ENCLOSURE 2
DESCRIPTION AND JUSTIFICATION
BROWNS FERRY NUCLEAR PLANT UNITS 1, 2, AND 3

Description of Change

ENCLOSURE 3
DETERMINATION OF NO SIGNIFICANT HAZARDS CONSIDERATION
BROWNS FERRY NUCLEAR PLANT UNITS 1, 2, AND 3

3.7.B. Standby Gas Treatment System

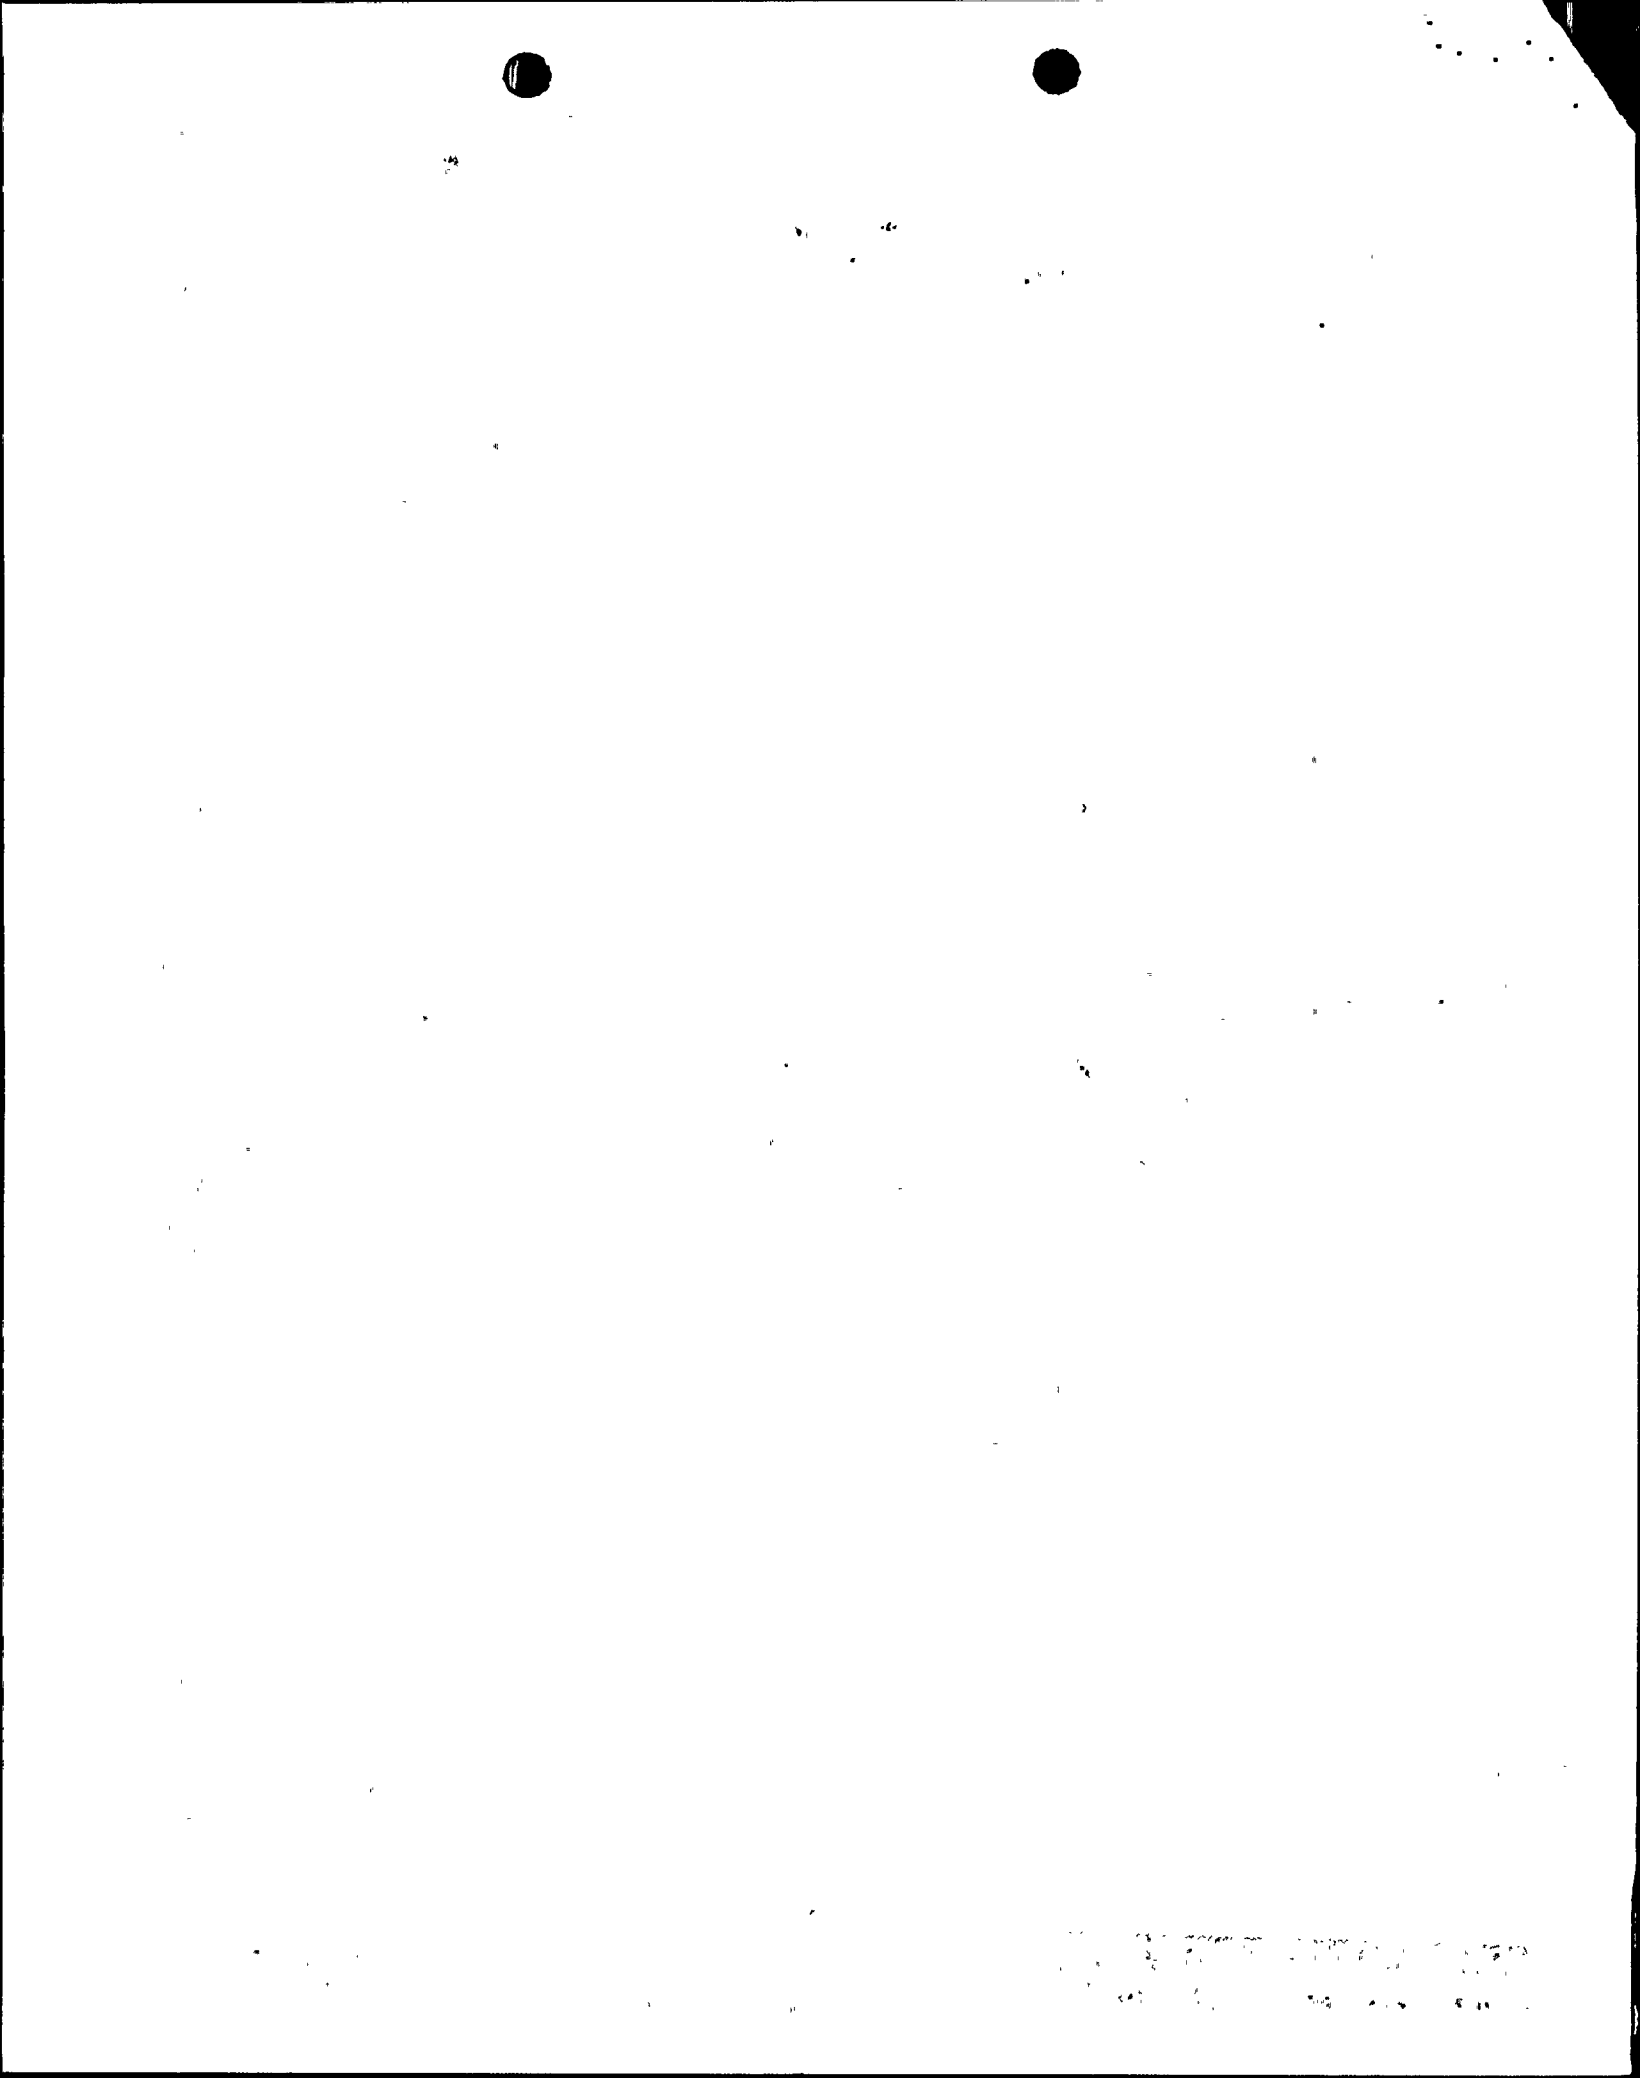
b. The results of laboratory carbon sample analysis shall show $\geq 90\%$ radioactive methyl iodide removal when tested in accordance with ASTM D3803 (130°C, 95% R.H.).

Technical specifications 3.7.B.2.b, 3.7.E.2.b, and 3.7.F.2.b are changed to reference the test method in ASTM D3803 vice ANSI N510-1975 for laboratory tests to demonstrate radioactive methyl iodide removal by carbon filter samples.

3.7.F. Primary Containment Purge System

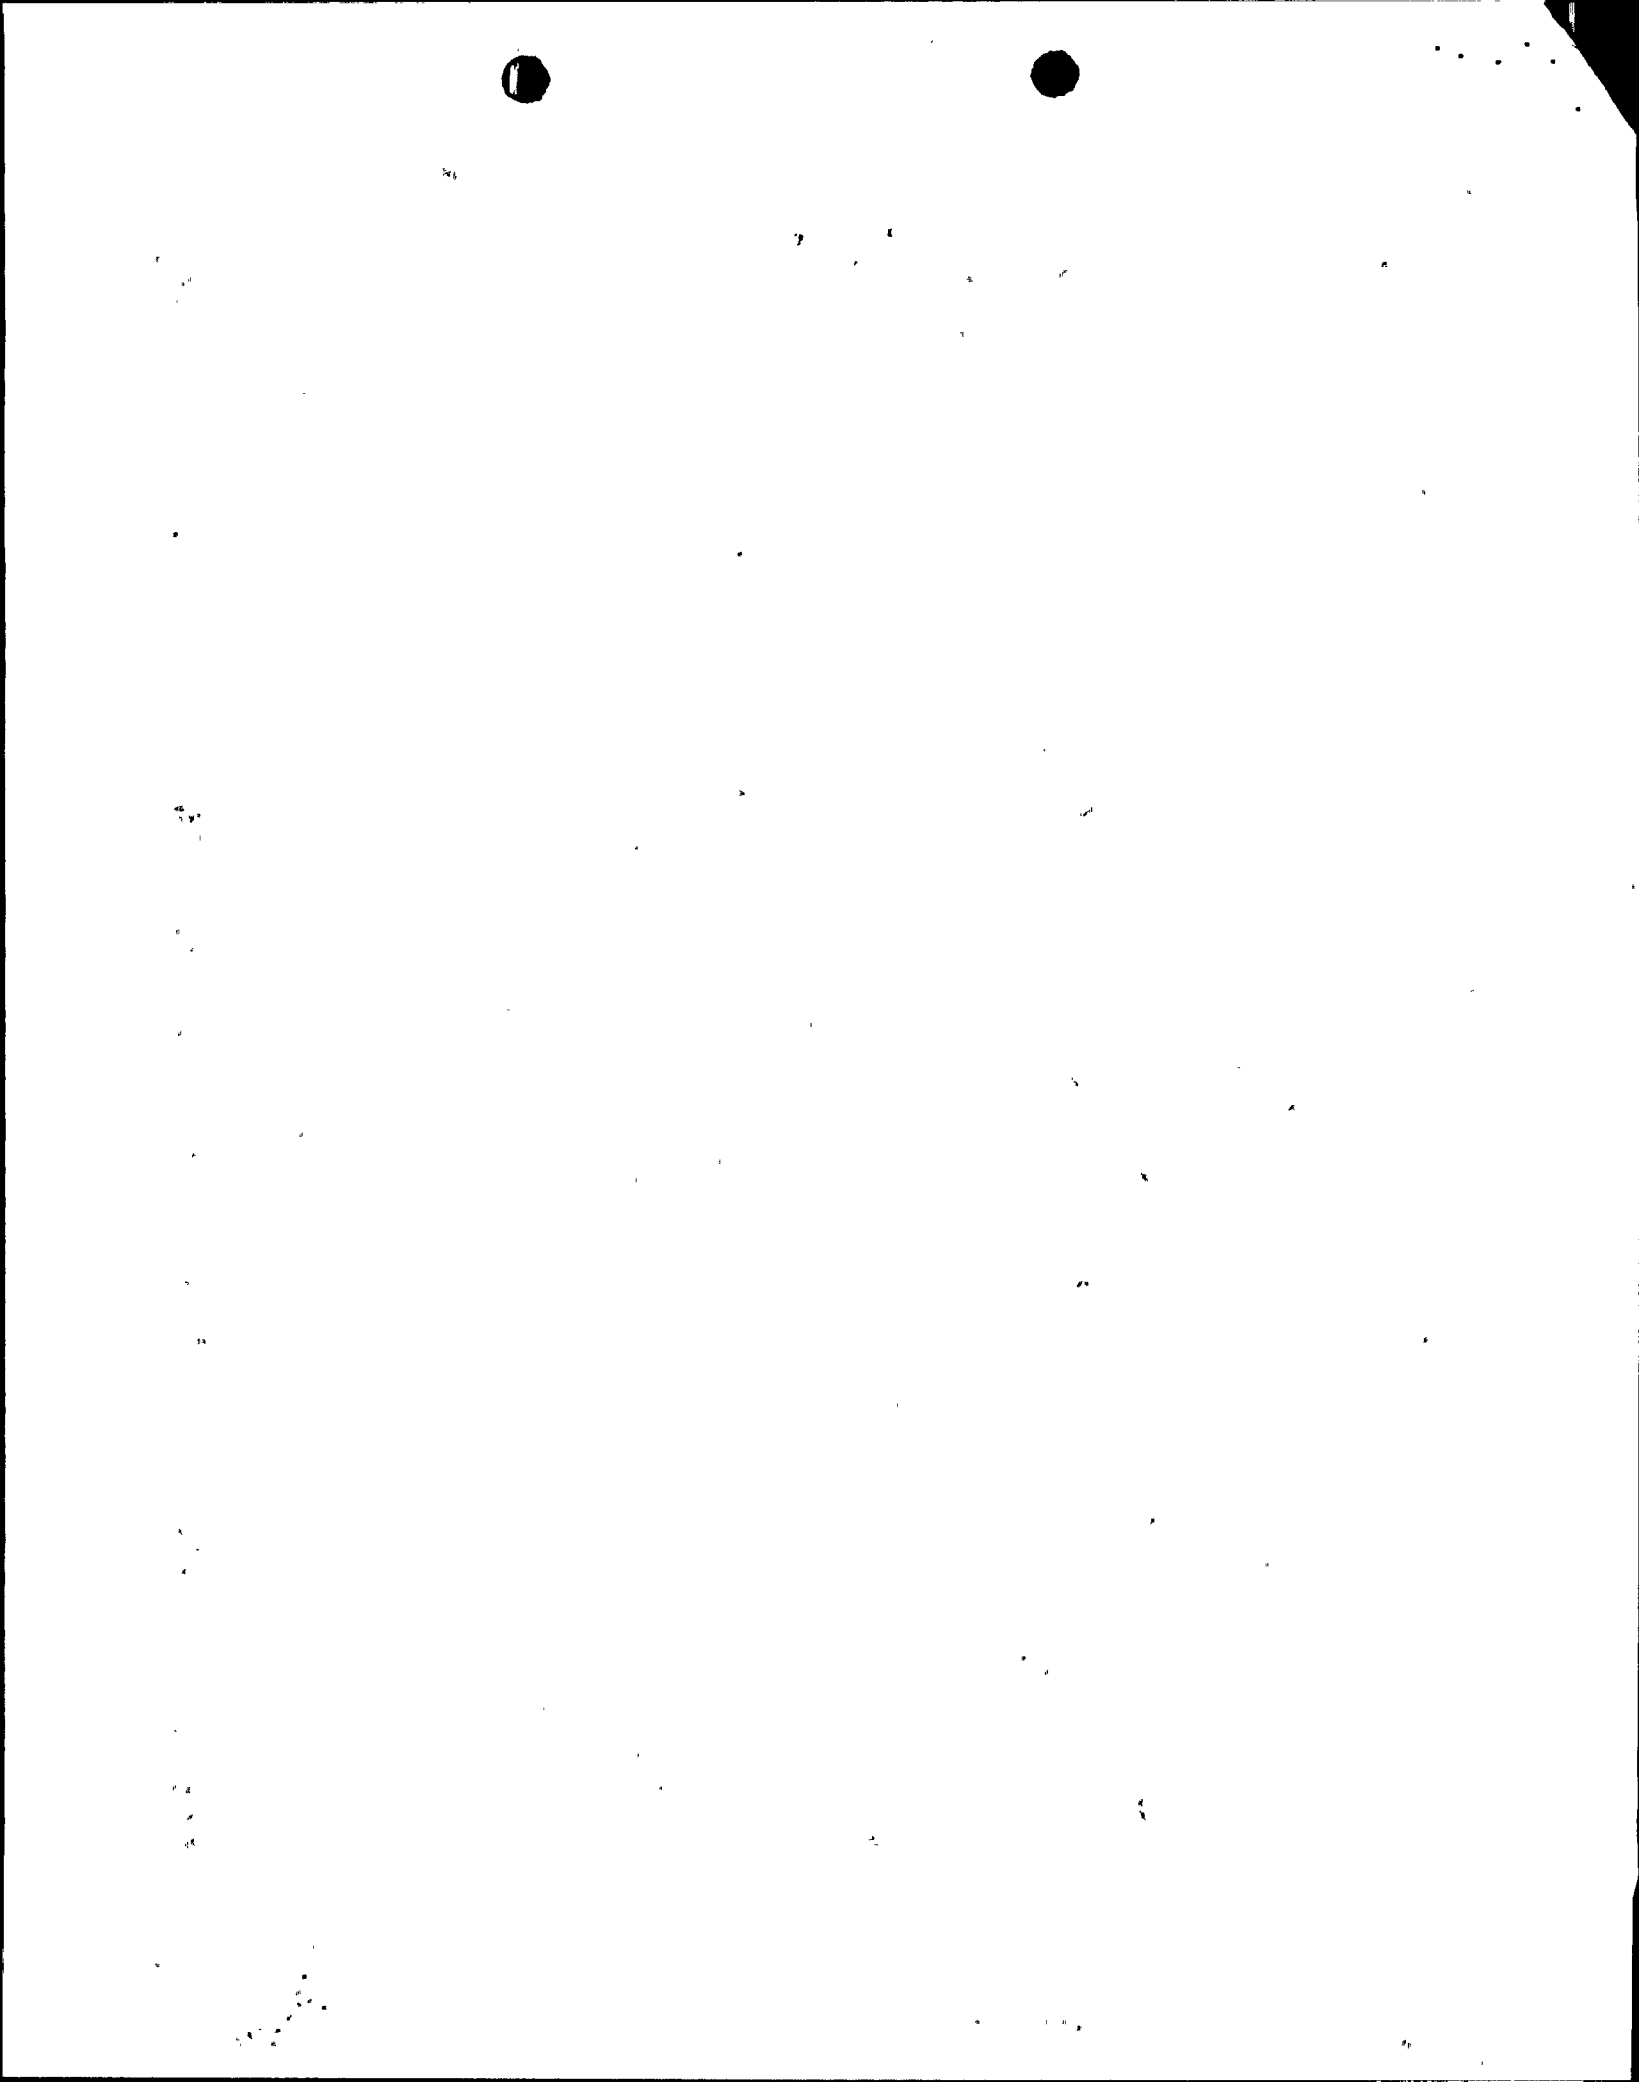
1. The primary containment shall be normally vented and purged through the primary containment purge system. The standby gas treatment system may be used when primary containment purge system is INOPERABLE.
2. a. The results of the in-place cold DOP and halogenated hydrocarbon tests at design flows on HEPA filters and charcoal adsorber banks shall show $\geq 99\%$ DOP removal and $\geq 99\%$ halogenated hydrocarbon removal when tested in accordance with ANSI N510-1975.
- b. The results of laboratory carbon sample analysis shall show $\geq 85\%$ radioactive methyl iodide removal when tested in accordance with ASTM D3803 (130°C 95% R.H.).
- c. System flow rate shall be shown to be within $\pm 10\%$ of design flow when tested in accordance with ANSI N510-1975.
